## Sheet RE-03 revision B (2 Nov 2026, PROPOSAL): the T1 slice in the prying pull, side view, pinned lugs at the z 24 load line

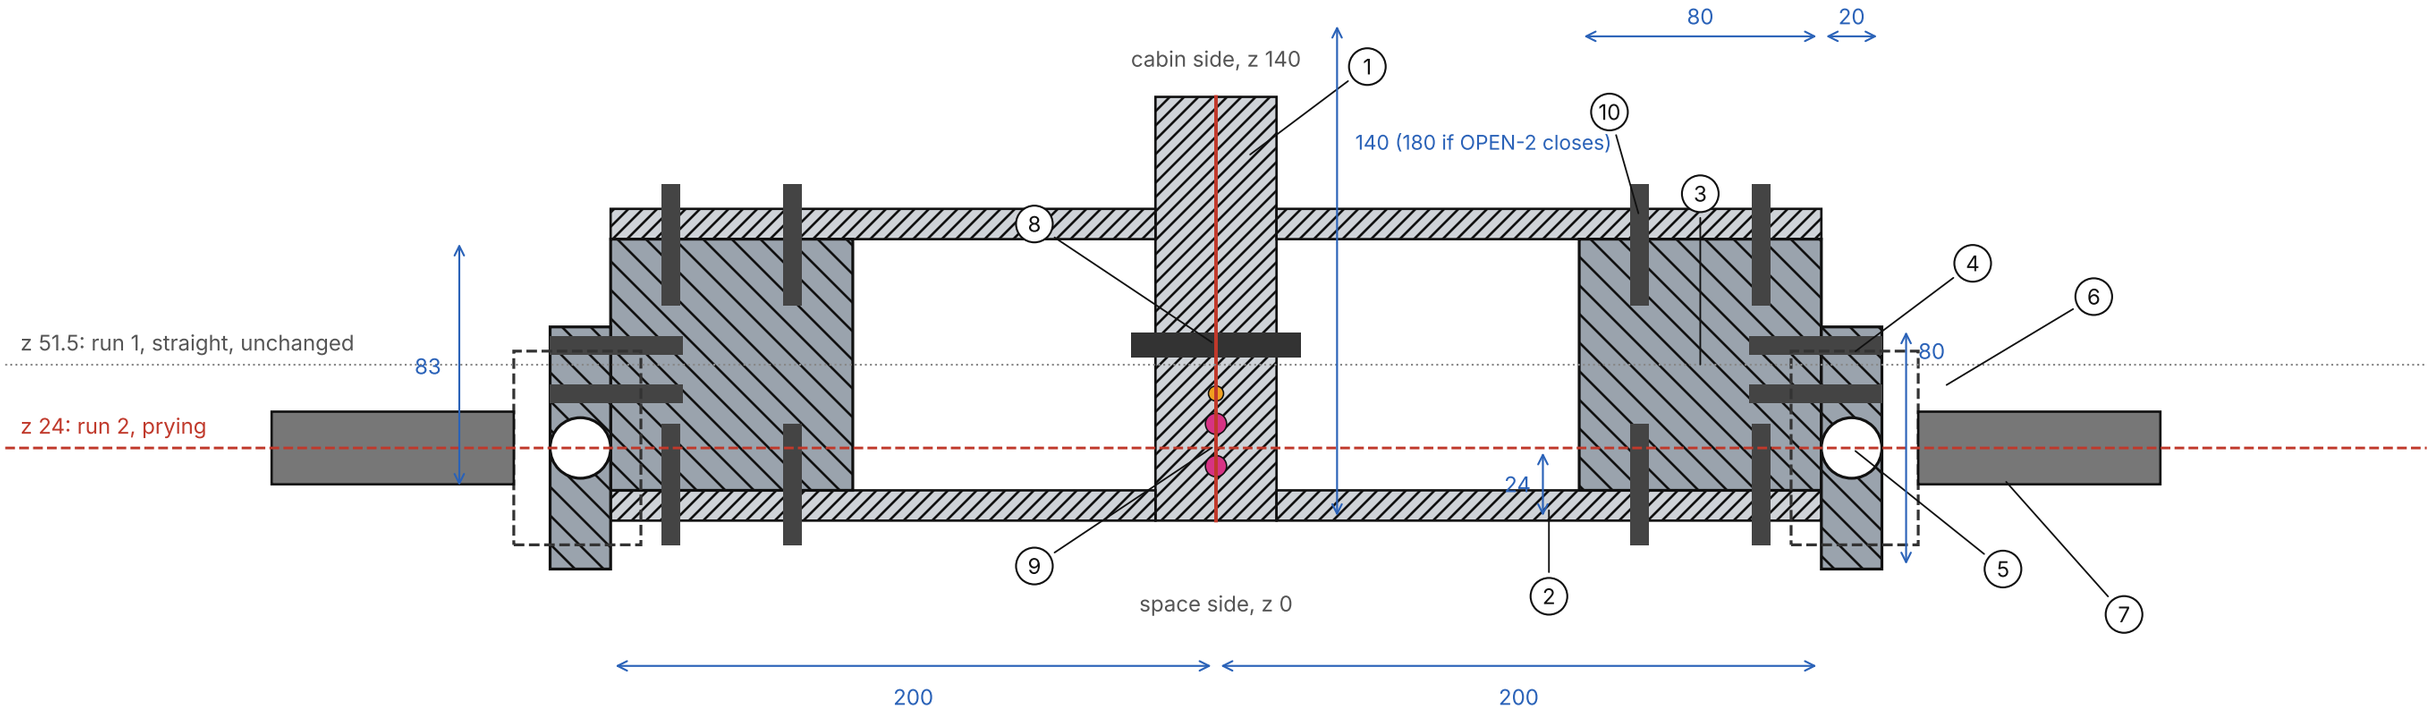
Both pull blocks hang from pins parallel to the seam axis, so each end turns freely and the pull through the outer flange pries the joint about its cabin-side edge, as the D1 run 2 model of 2 Nov assumes. Only the z 24 M24 thread goes; everything else on RE-01 to RE-03 stays.

3 Pull block, 4140 QT 28 to 32 HRC, 83 × 80 x slice length, unchanged except: the z 24 M24 thread is deleted; 4 x M12 × 1.75 tapped holes 20 deep in the pull face at z 42 and z 58, 30 mm either side of mid-length.

4 NEW lug plate F-01: 4140 QT, 80 (x) x 80 (z) x 20 thick, screwed to the pull face with 4 x M12 × 45 class 12.9 and hardened washers; it hangs 16 mm below the block's outer face. Pin hole 20 H7 at z 24, 40 mm from the lug's lower edge (2d).

5 NEW pin F-03: 20 h6 × 70, 17-4PH H900 or 4140 QT, with a shoulder and an E-clip; greased.

6 NEW fork F-02: 4140 QT, two cheeks 15 thick with a 21 mm gap, 20 H8 holes, body 60 × 60 with the M24 × 3 female thread for the existing Instron adapter; one fork each end, same for all three slice lengths.
